ADA Curb Ramp New Construction Inspection Form (Parallel)

Main	24952.54			Hillcrest
North-South Road Name	Project No.	Sheet No.	Intersection No.	East-West Road Name

PARALLEL RAMP (PL)

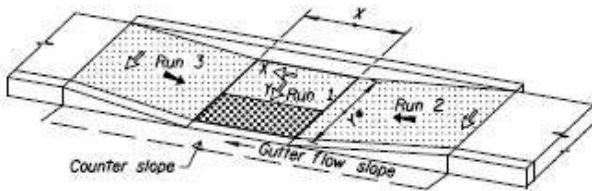
Pass	Fail
RAMP RUN 1				
Running Slope 1	2.4	≤ 2.0%	<input type="checkbox"/> > 2.0%	<input checked="" type="checkbox"/>
Cross Slope 1		≤ 2.0%	<input type="checkbox"/> > 2.0%	<input type="checkbox"/>
Detectable Warning	Y	Y	<input checked="" type="checkbox"/> N	<input type="checkbox"/>
Lip Height	0	≤ 1/4"	<input checked="" type="checkbox"/> > 1/4"	<input type="checkbox"/>
Gutter Flow Slope	0.9	≤ *	<input checked="" type="checkbox"/> > *	<input type="checkbox"/>
Curb Running Slope (avg)	<input type="checkbox"/> 12.46	≤ 8.3%	<input type="checkbox"/> > 8.3%	<input checked="" type="checkbox"/>
Counter Slope (+/-)*2	0.8	≤ 5.0%	<input checked="" type="checkbox"/> > 5.0%	<input type="checkbox"/>
Det. warning full width of ramp		Y	<input type="checkbox"/> N	<input type="checkbox"/>

RAMP RUN 2				
Running Slope 2		≤ 8.3%	<input type="checkbox"/> > 8.3%	<input type="checkbox"/>
Length 2	7.45			
Cross Slope 2	2.6	≤ 2.0%	<input type="checkbox"/> > 2.0%	<input checked="" type="checkbox"/>
RAMP RUN 3				
Running Slope 3	9.3	≤ 8.3%	<input type="checkbox"/> > 8.3%	<input checked="" type="checkbox"/>
Length 3	7.4			
Cross Slope 3		≤ 2.0%	<input type="checkbox"/> > 2.0%	<input type="checkbox"/>

IITD gt2. Ramps abut.
